Sheringham Shoal and Dudgeon Offshore Wind Farm Extension Projects

Supplementary Environmental Report

Non-material Change Application

Document Reference: 26.2

Figure 1 Total Rotor-Swept Area

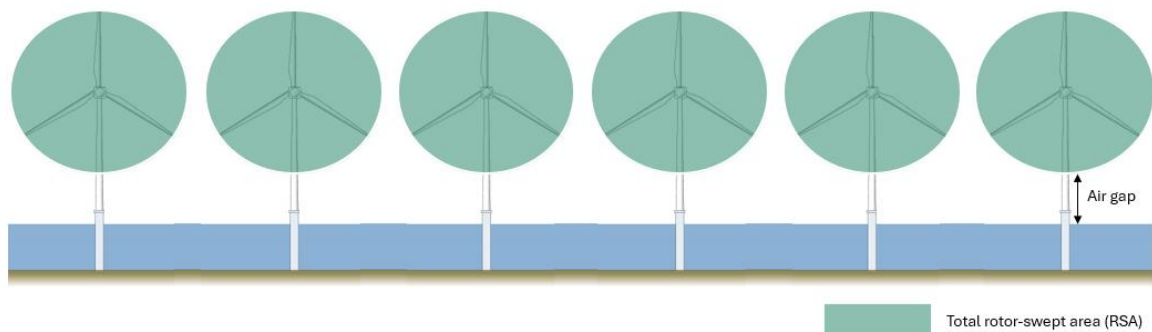
28. The NMC application proposes changes to the Total RSA for SEP and Total RSA for DEP, as set out in **Table 2.1**.
29. The Total RSA is the combined swept path taken up by all wind turbine rotors within the SEP wind farm site or within the DEP wind farm site (**Figure 1**). The swept path of an individual turbine is calculated based on its rotor diameter. The Total RSA is therefore calculated by multiplying the total number of wind turbines installed by the swept area of a single wind turbine for a specific rotor diameter.

30. Whilst the Order secures a maximum rotor diameter of 300 m, the Order does not allow for the maximum number of turbines (23 wind turbines in SEP and 30 wind turbines in DEP) to be installed with a 300 m rotor diameter because that would result in an exceedance of the maximum Total RSA specified in the Order. Therefore, the worst-case scenario which informed the offshore ornithology assessments in the DCO application submissions was based on 23 wind turbines in SEP and 30 wind turbines in DEP, each with a 235 m rotor diameter. In order to realise the increase in maximum generating capacity whilst ensuring the magnitude of collision risk effects is no greater than that previously assessed, three NMC RSA Bands have been defined and collision risk modelling undertaken based on the different wind turbine parameters in each NMC RSA Band. In each case, the modelled rotor diameter represents the worst-case scenario for collision risk for that RSA Band. Further detail on the wind turbine parameters for each NMC RSA Band is provided in **Table A-3** of Appendix A.

31. The RSA bands are set out in **Table 2.1** and explained as follows:
- **Band 1** limits Total RSA to 1.01 km² and 1.31 km² for SEP and DEP, respectively, and allows for the maximum number of turbines (23 for SEP and 30 for DEP) with a maximum rotor diameter of 236 m.

- **Band 2** limits Total RSA to 1.13 km² and 1.47 km² for SEP and DEP, respectively, and allows for the maximum number of turbines (23 for SEP and 30 for DEP) with a maximum rotor diameter of 250 m.

- **Band 3** limits Total RSA to 1.42 km² and 1.85 km² for SEP and DEP, respectively, and allows for the maximum number of turbines (23 for SEP and 30 for DEP) with a maximum rotor diameter of 280 m.

Parameter	Order	NMC RSA Band 1	NMC RSA Band 2	NMC RSA Band 3
Air Gap (above HAT)	30m	30m	31m	32m
SEP maximum RSA (km ²)	1.00	1.01	1.13	1.42
DEP maximum RSA (km ²)	1.30	1.31	1.47	1.85

Figure 2 Interlink cable changes required in relation to Scenarios 1, 2 and 3 with four cables between DEP-N and DEP-S

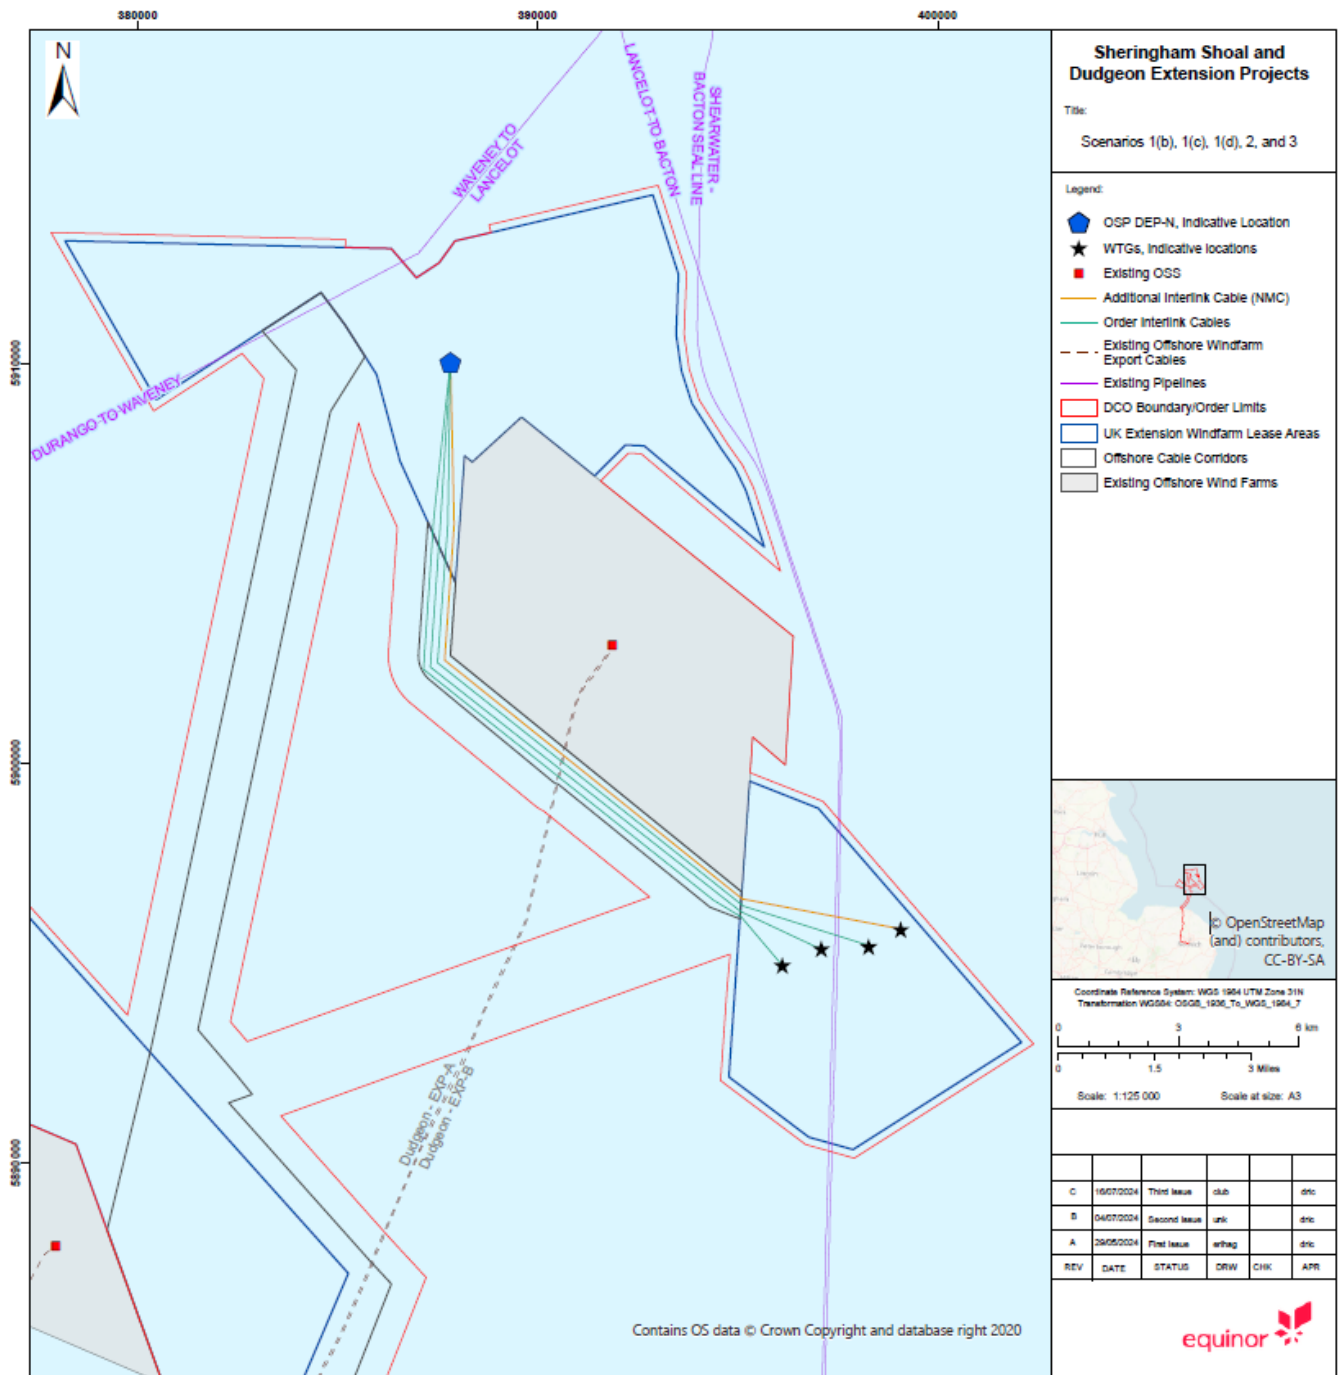
36. For Scenarios 1(c), 1(d), 2 or 3, an increase from three to four interlink cables is needed in the event two OSPs are constructed (**Figure 2**) or in the case that only DEP is constructed (Scenario 1(b) - **Figure 2**). For all of these scenarios, the interlink cables connect an OSP in DEP-N to turbines in the DEP South array area (DEP-S). For those scenarios where two OSPs are constructed, the second OSP in SEP does not connect to any of the interlink cables and is therefore not shown in **Figure 2**.

42. For all of these scenarios, the one additional interlink cable would make up to four crossings of existing third-party infrastructure (**Figure 2** - the additional interlink cable is shown in yellow), crossing the:

- Dudgeon Export A cable;
 - Dudgeon Export B cable;
 - Lancelot to Bacton gas pipeline; and
 - Shearwater to Bacton gas pipeline.
43. Additionally, one crossing of the Lancelot to Bacton gas pipeline and one crossing of the Shearwater to Bacton gas pipeline in DEP-S, that were considered infield cable crossings (Work No. 2B) in the Order, are more accurately considered interlink cable crossings (Work No. 4B) as the interlink cable will connect to a wind turbine within DEP-S after having crossed the existing gas pipelines (and having originated in DEP-N). These crossings are therefore reallocated accordingly from Work No. 2B to Work No. 4B as part of this NMC.

44. A summary of the revised numbers of crossings for scenarios 1, 2 and 3 is as follows:
- Six interlink cable crossings (Work No. 4B) and seven infield cable crossings (Work No. 2B) were included in the Order.
 - Up to an additional four interlink cable crossings are needed in relation to the one additional interlink cable, crossing the Dudgeon Export A cable, the Dudgeon Export B cable, the Lancelot to Bacton gas pipeline and the Shearwater to Bacton gas pipeline.
 - There is a reallocation of two crossings in DEP-S from infield, Work No. 2B, to interlink, Work No. 4B.
 - The revised numbers of crossings are therefore 12 interlink cable crossings in Work No. 4B (an increase of six) and five infield cable crossings in Work No. 2B (a reduction of two).
 - There is no change to the number of crossings in relation to the offshore export cables.

Figure 3 Interlink cable changes required in relation to Scenario 4 with four cables between SEP and DEP-N and four cables between SEP and DEP-S

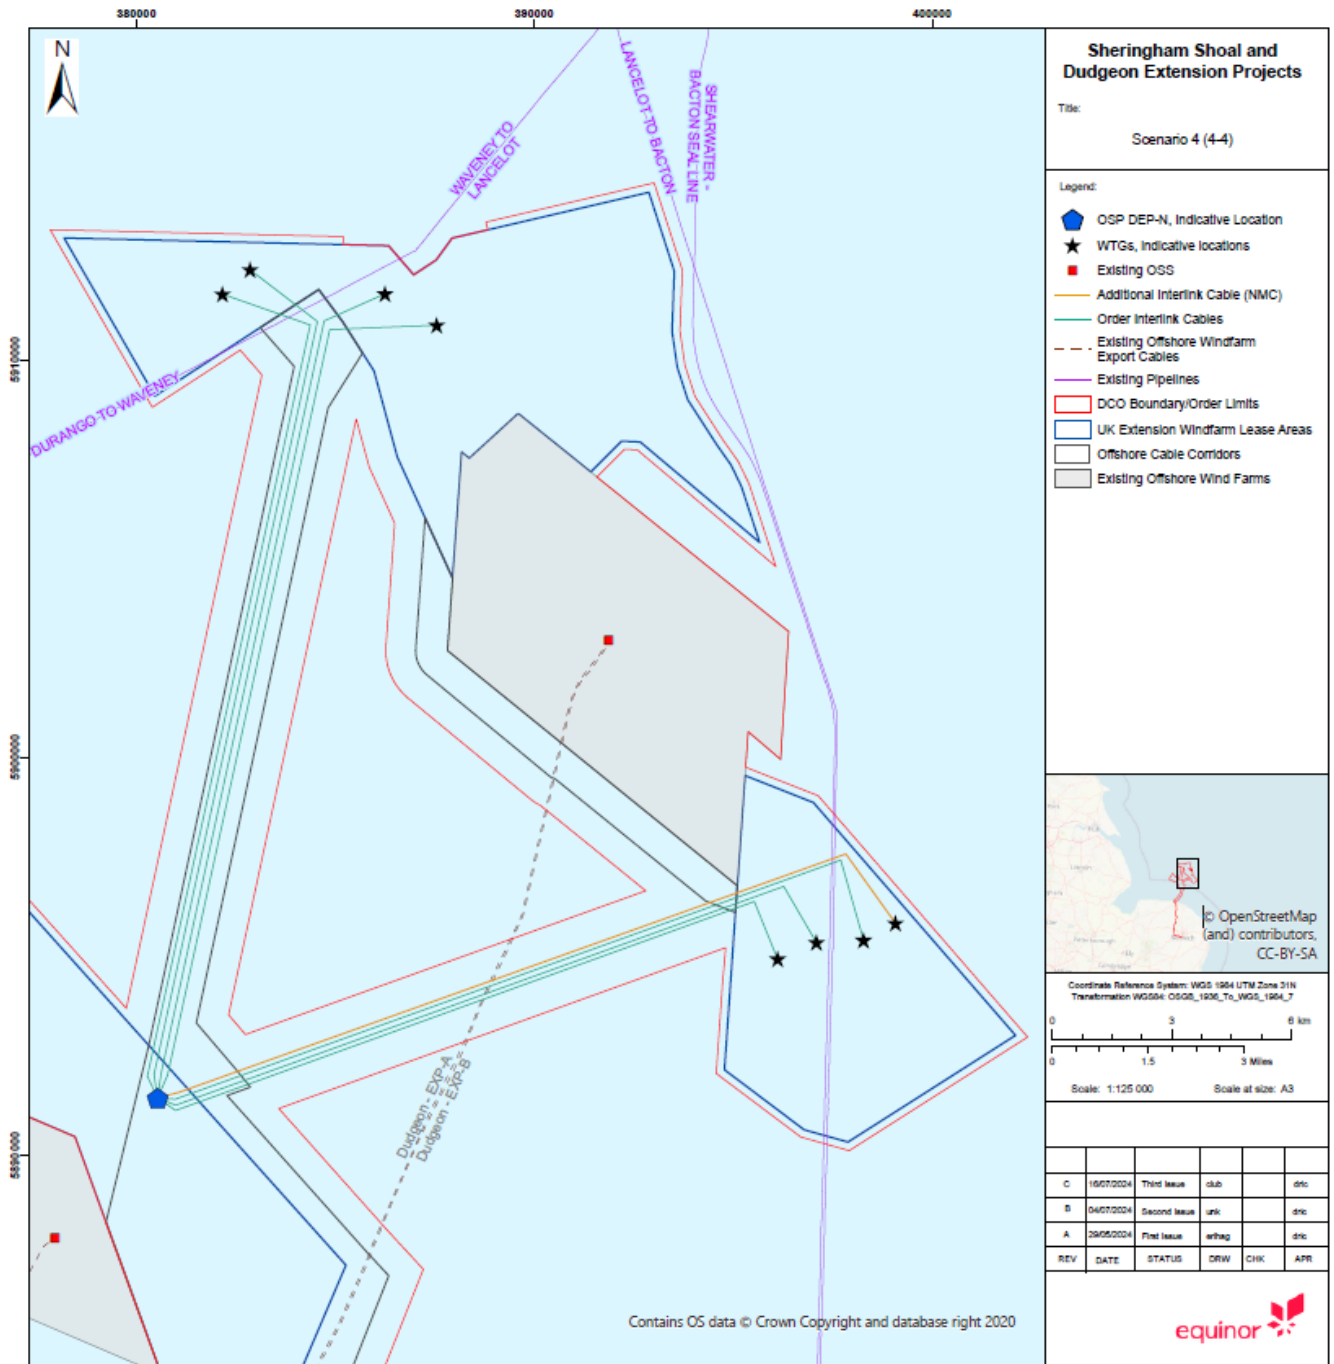
- Four interlink cables connecting the OSP in SEP to wind turbines in DEP-N and four interlink cables connecting the OSP in SEP to wind turbines in DEP-S (**Figure 4**); or

46. For both of these permutations, there is one additional interlink cable (Work No. 4C) when compared to the relevant layouts reflected in the parameters in Table 4.20 of the **Project Description (Revision C)** [document reference 6.1.4]. The additional interlink cable is shown in yellow in **Figure 4** and **Figure 4**.

47. For both layout permutations considered for Scenario 4, the one additional interlink cable would make up to four crossings of existing third-party infrastructure (**Figure 4** and **Figure 4**), crossing:

49. A summary of the revised numbers of crossings for Scenario 4 is as follows:
- Six interlink cable crossings (Work No. 4C) and seven infield cable crossings (Work No. 2B) were included in the Order.

Figure 4 Interlink cable changes required in relation to Scenario 4 with five cables between SEP and DEP-N and three cables between SEP and DEP-S

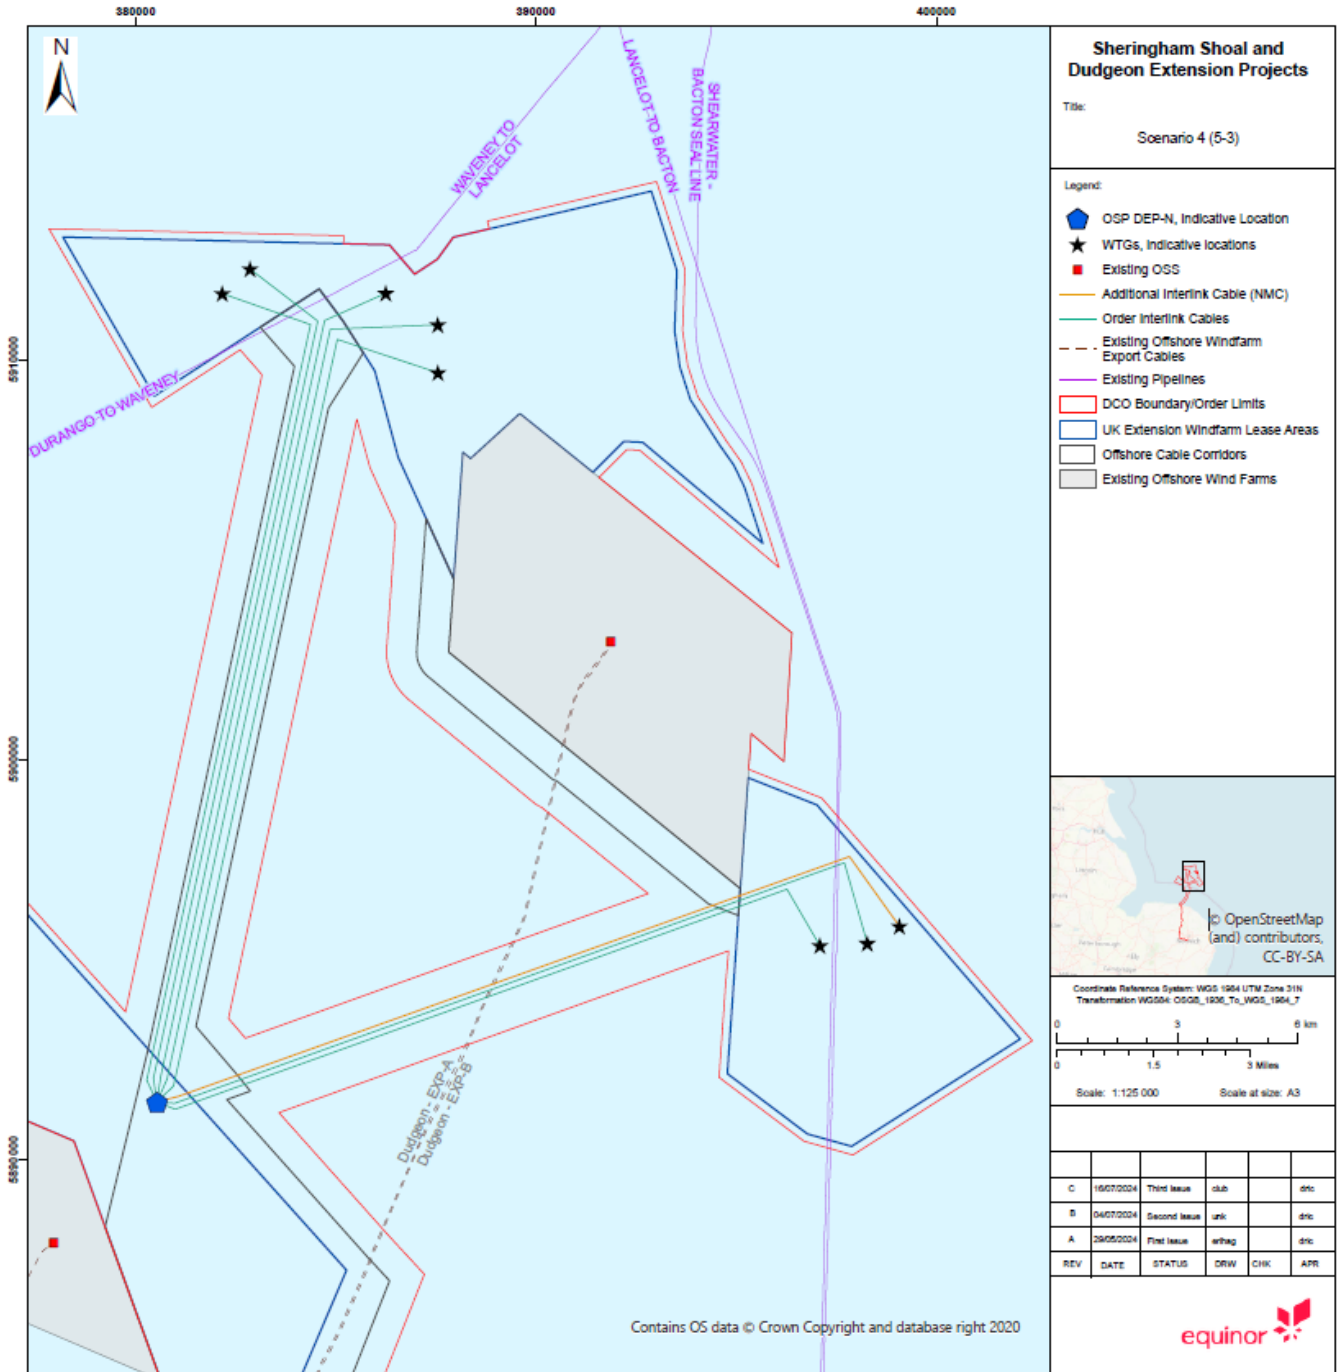
- Five interlink cables connecting the OSP in SEP to wind turbines in DEP-N and three interlink cables connecting the OSP in SEP to wind turbines in DEP-S (**Figure 4**).
